# General Service Bulletin

YC-SB-10A

**SUBJECT:** Two (2) Speed Combustion Blower Motor Failures on Mid-Range Voyager Gas/Electrics

6.25 - 7.50 TON UNITS

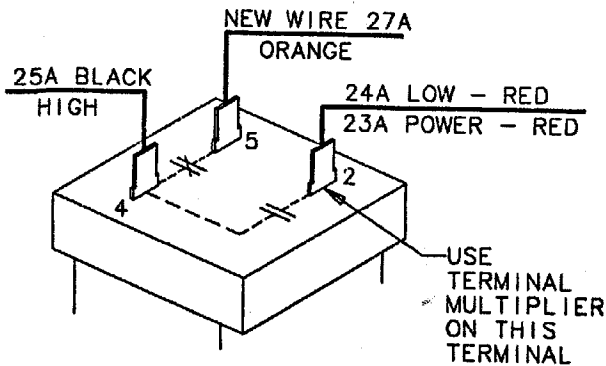
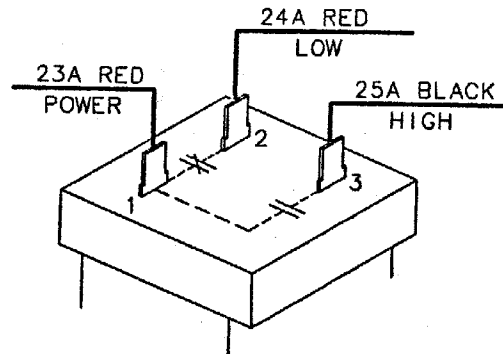
# COMBUSTION FAN RELAY (CFR) WIRING CHANGE

EXISTING WIRING ARRANGEMENT

REVISED WIRING ARRANGEMENT

8.5 - 20.0 TON UNITS

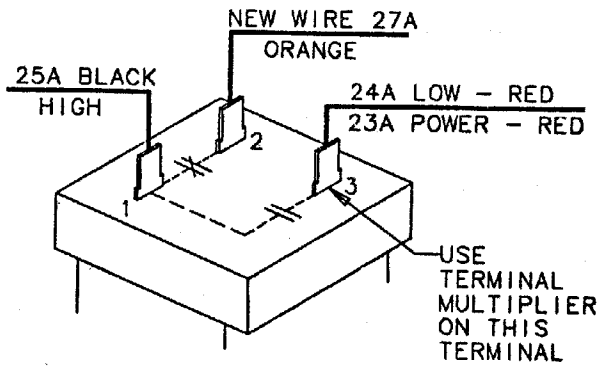
EXISTING WIRING ARRANGEMENT

REVISED WIRING ARRANGEMENT
